Product Improvement Notice - New extrusion for 07 series baggage doors

Please be advised LCI is changing the extrusion on our 07 series baggage doors to improve fit and function.

New

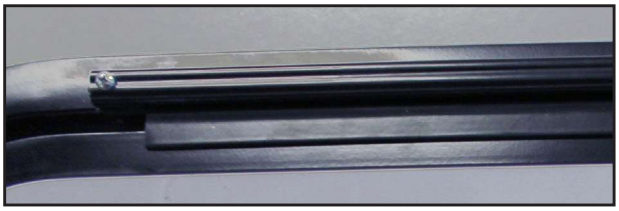
The new extrusion has a flange to divert water away from the seam. The extrusion also has a tighter tolerance in the hinge area that provides a tighter fit and smother function between the seam and door.

For replacement, if a door is damaged a new door can be inserted into the existing frame. Due to the change in profile, however, only a new hinge-side door will work with a new hinge-side frame, and vice versa with the current door/frame.
